ADDENDUM # 002

**Our Lady of Fatima
545 Baldoon Rd
Chatham, ON**

New Exterior Wall Assembly, Universal Washroom and In-coming Water Service Project No. 619-CP1835

June 4th. 2018

3
A500
TYP. WALL SECTION @ 1987
ADDITION
1:15

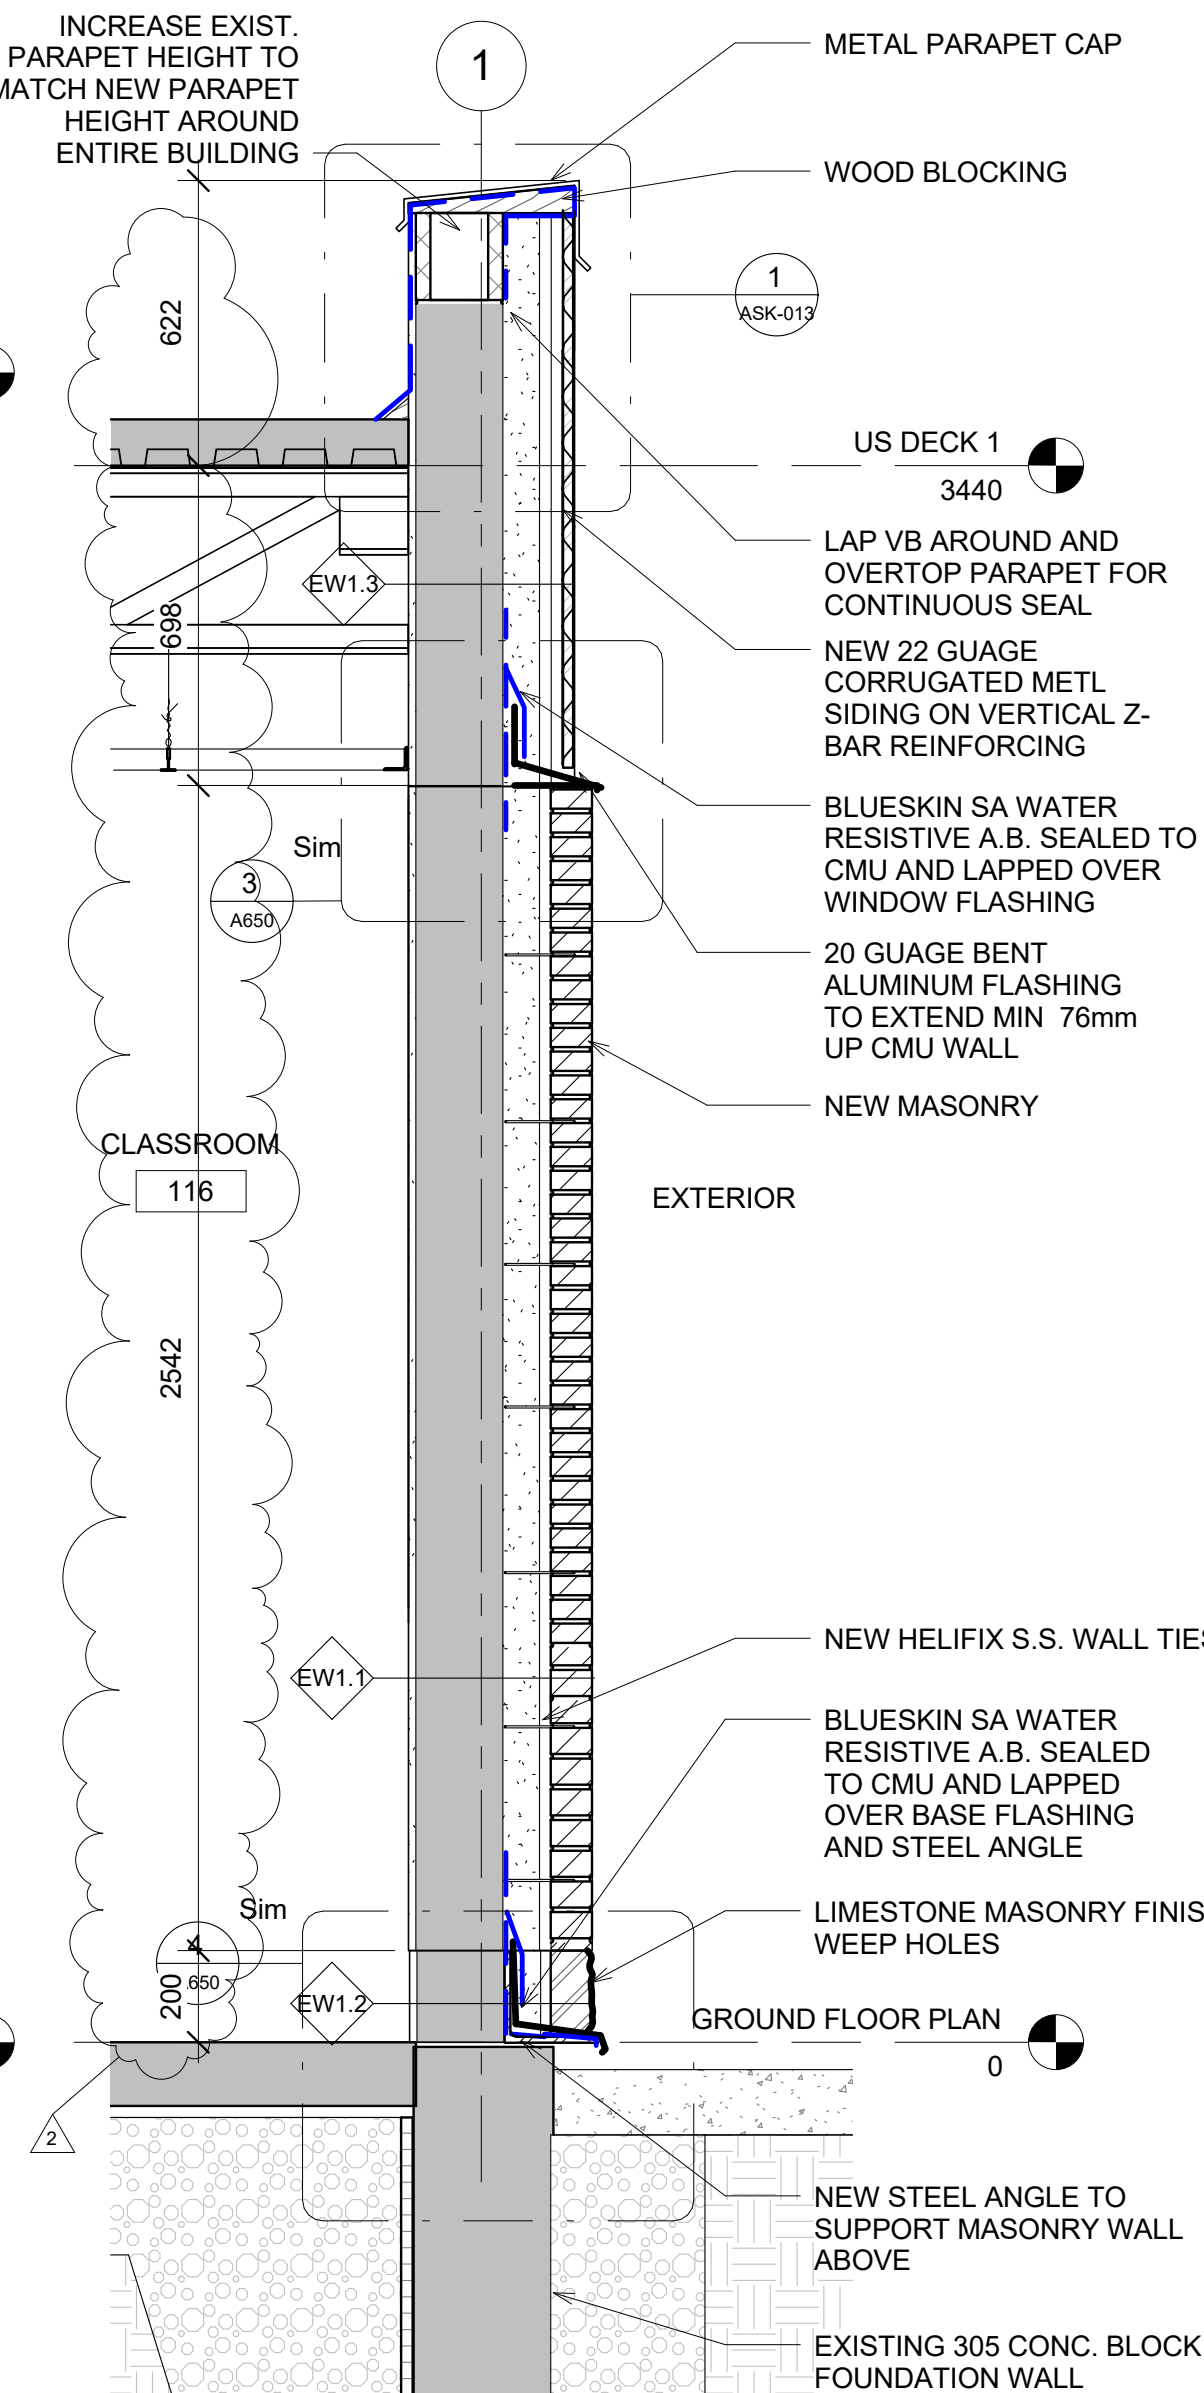
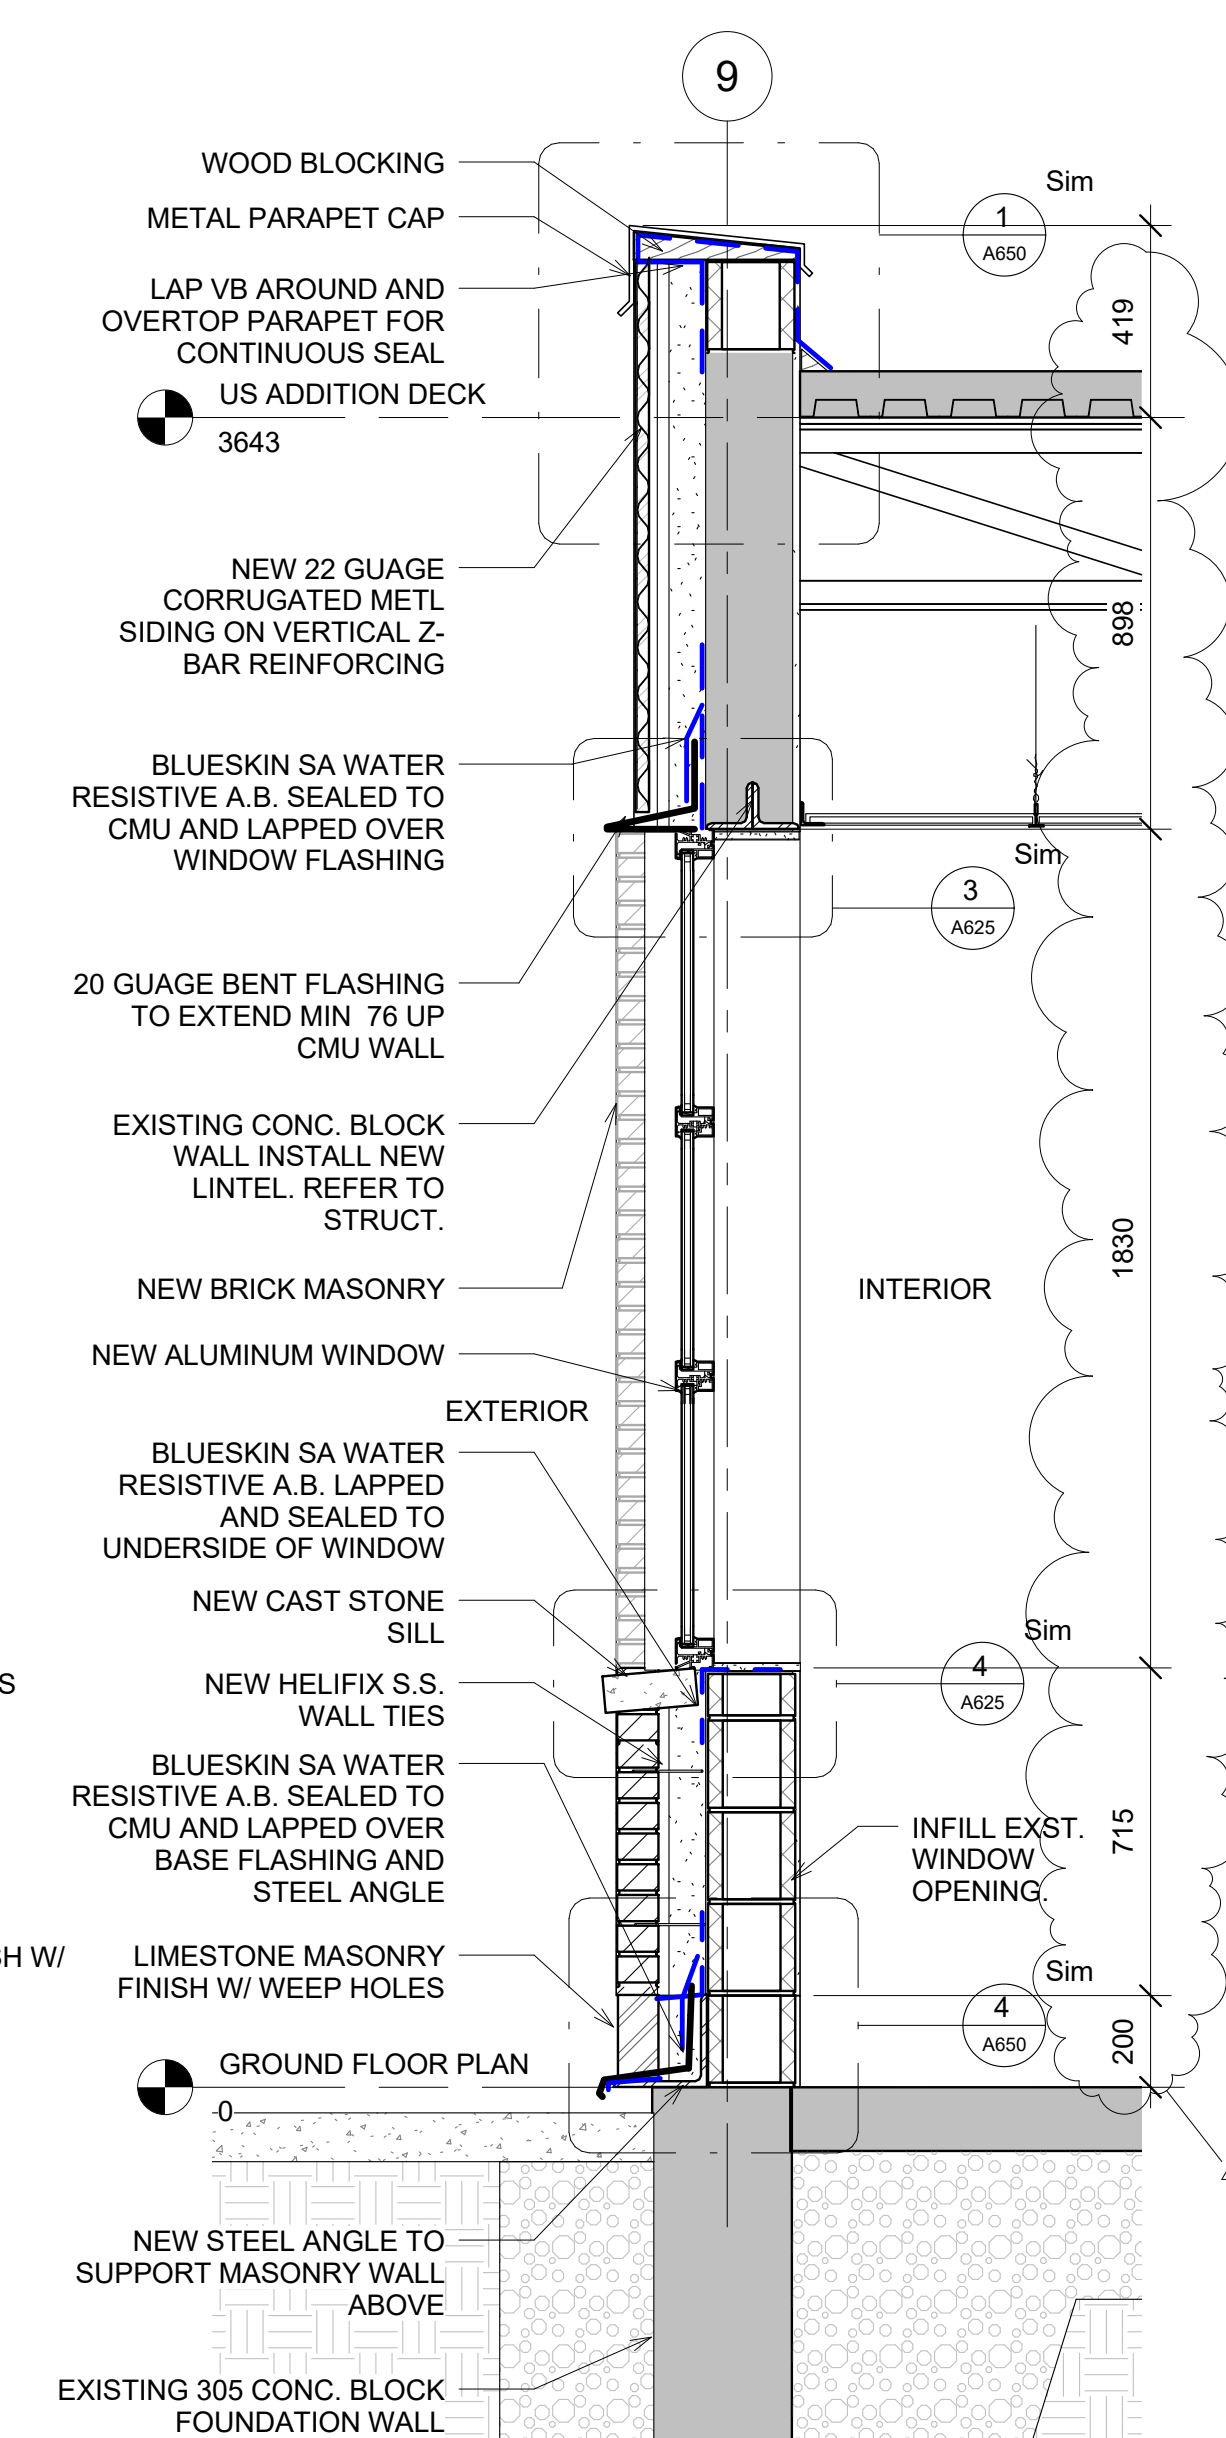
A500 – Wall Sections: Reissued showing the wall dimensions and parapet heights.

Non-Freeze Wall Hydrant with NB Box, Integral Vacuum Breaker

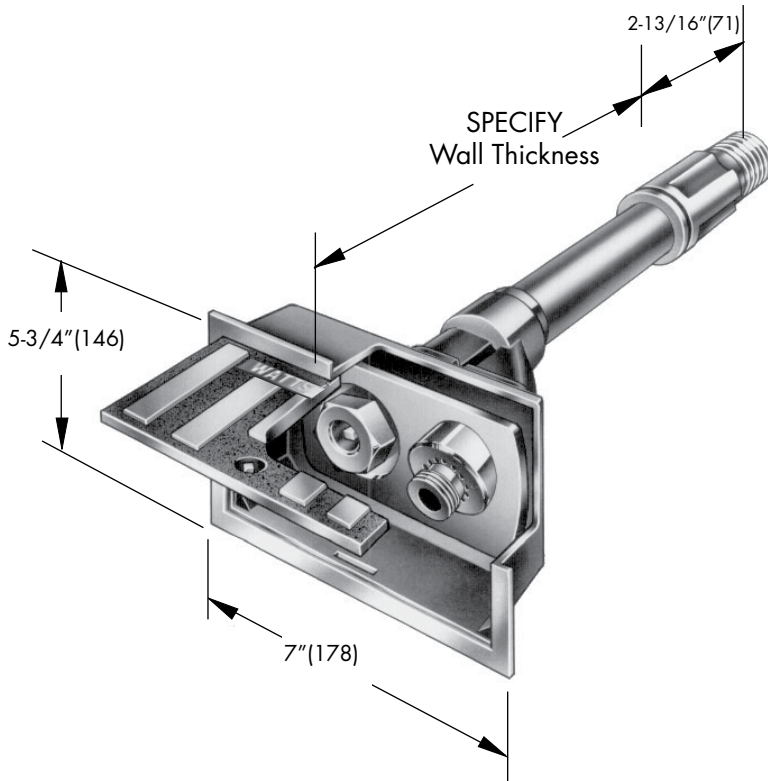
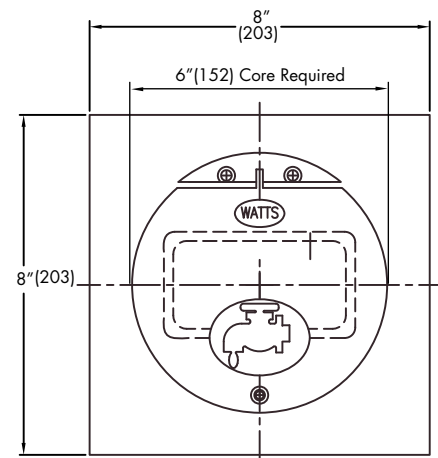
Answer: Hose bibs on the perimeter of the school are to be removed and reinstalled after the new wall finishes are applied. A bib extension will be required, which is specified in the attached cut sheet.

DRAWING TITLE
**PARTIAL GROUND FLOOR PLAN - SOUTH
LIGHTING AND FIRE ALARM**

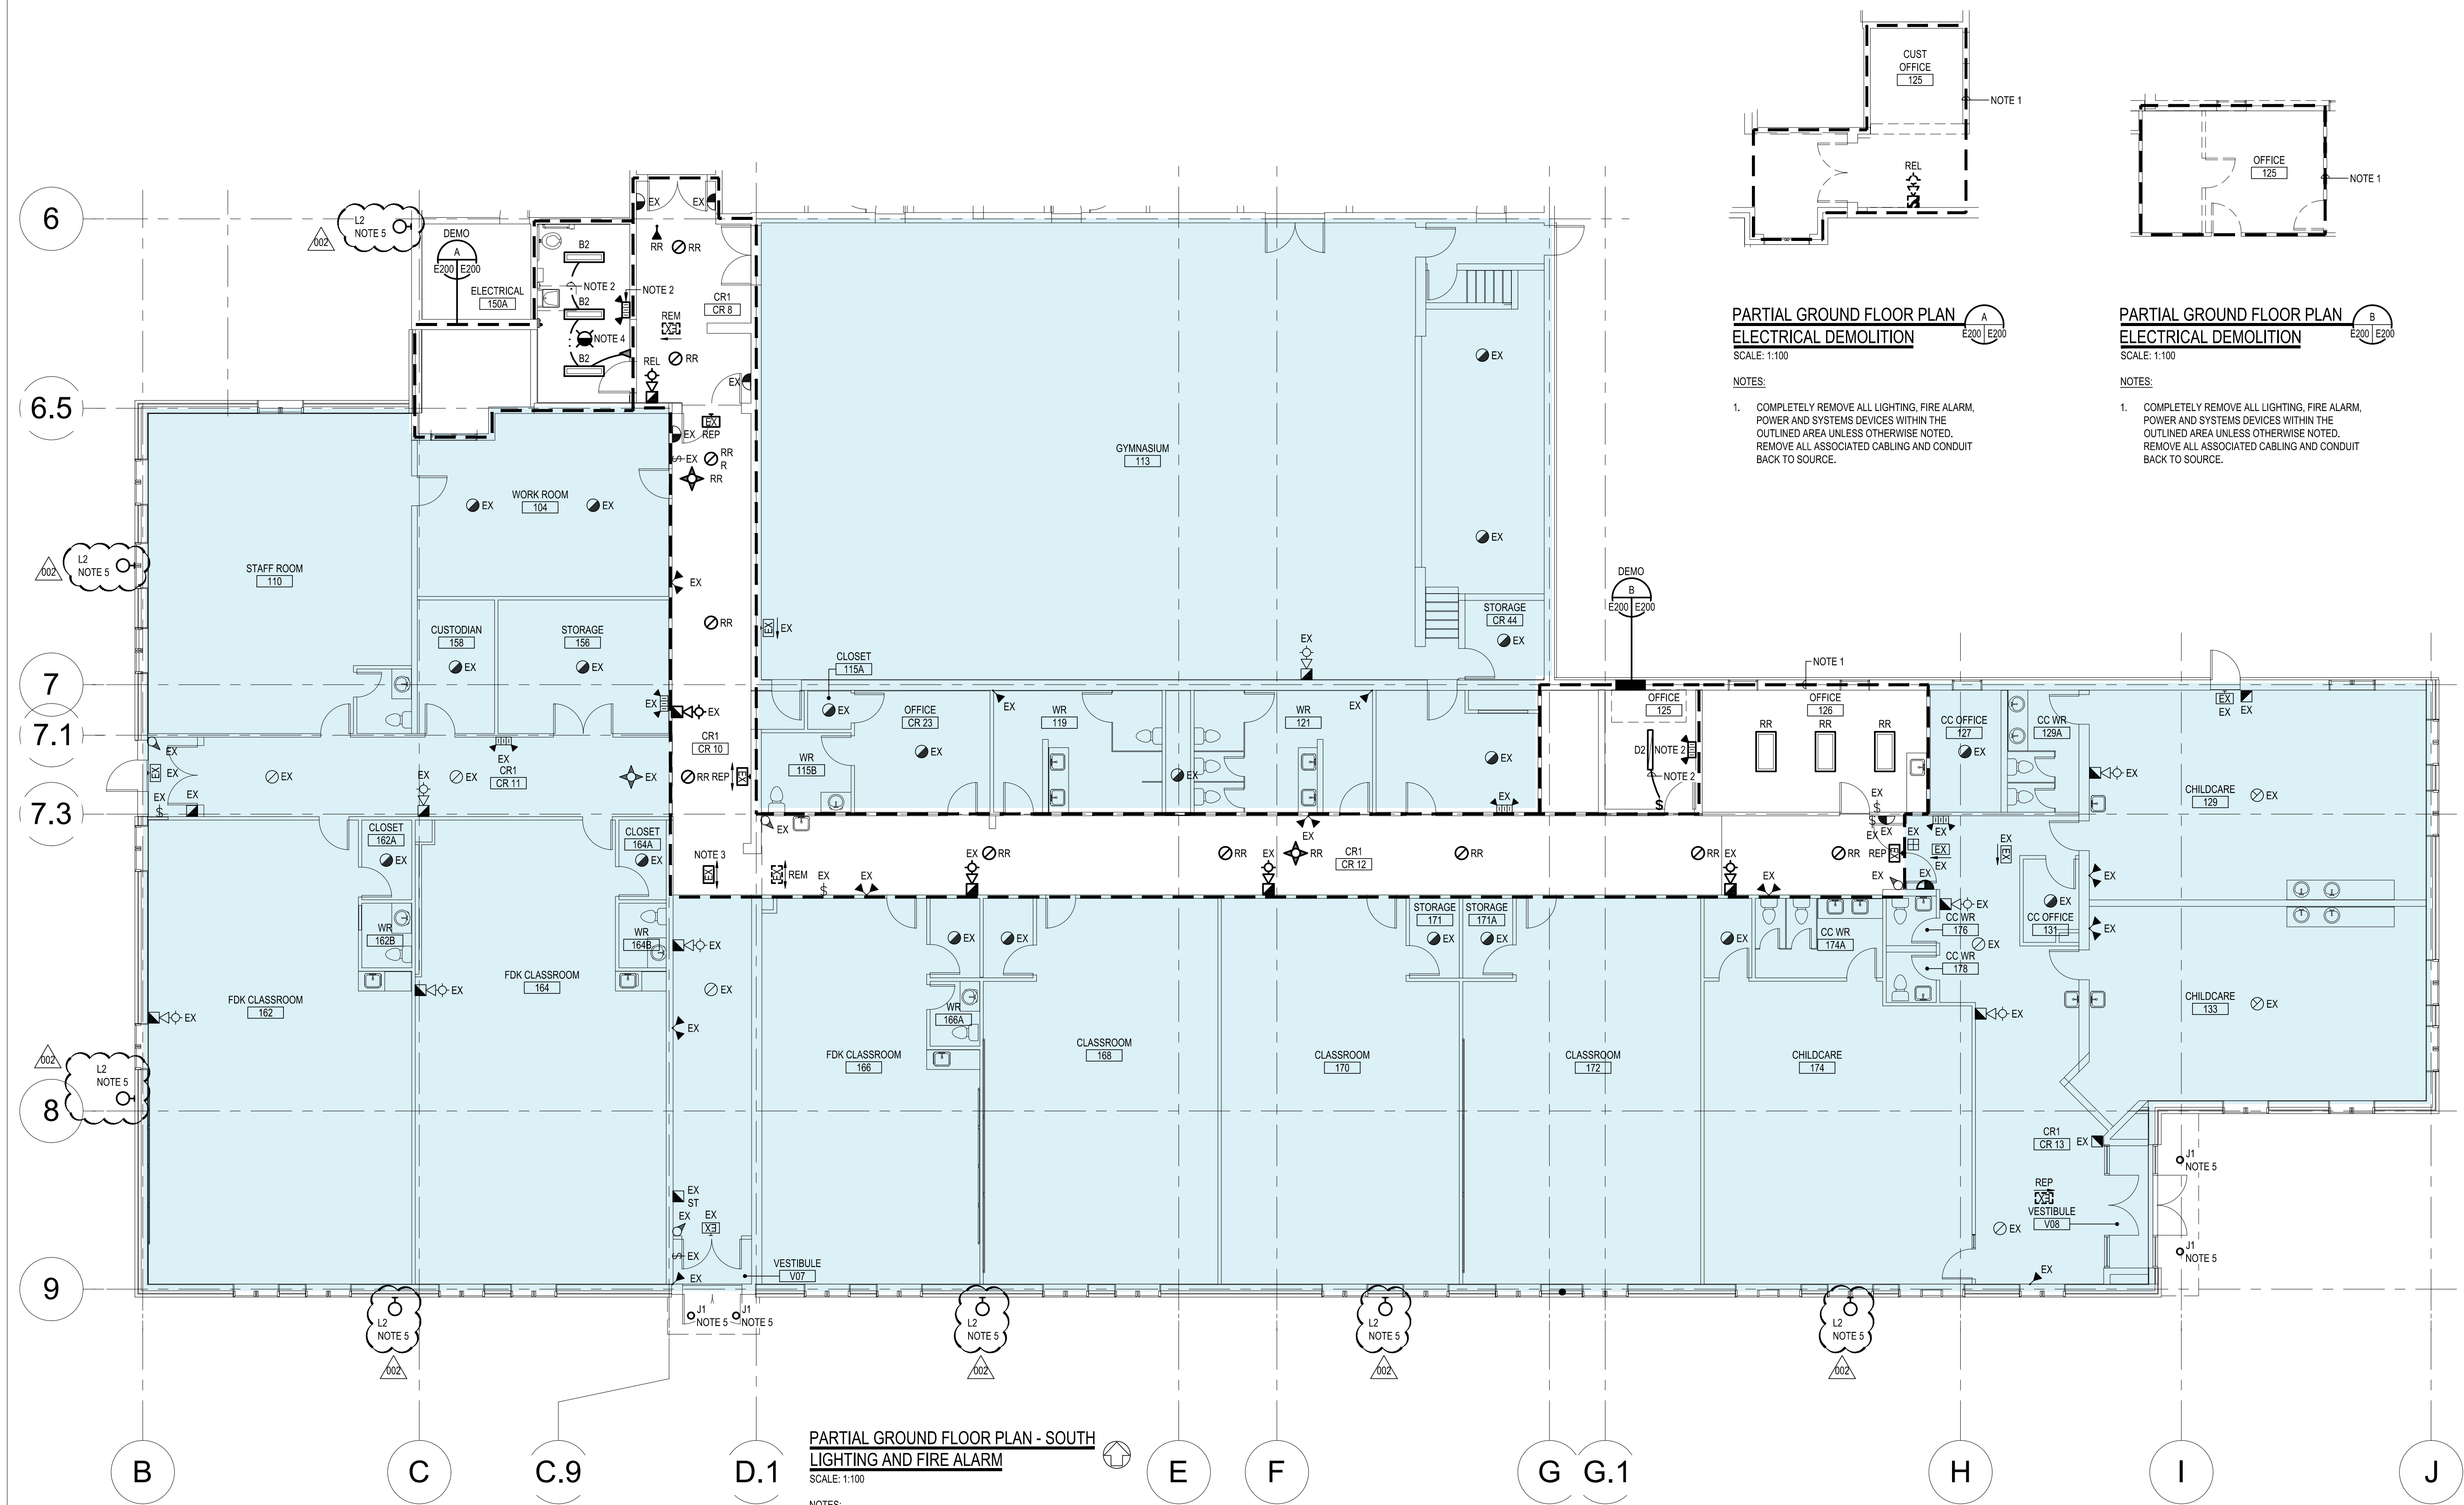
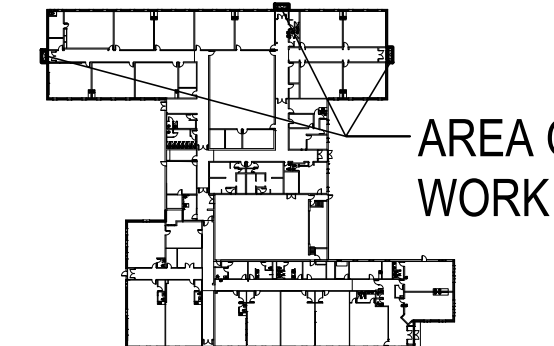
New down light fixtures will be installed along perimeter of the school to provide lighting for the sidewalks. These light fixtures will be permanent, please refer to attached electrical drawings and specification provided with this addendum.

Electrical Drawing E200 – Partial Ground Floor Plan – South Lighting and Fire Alarm
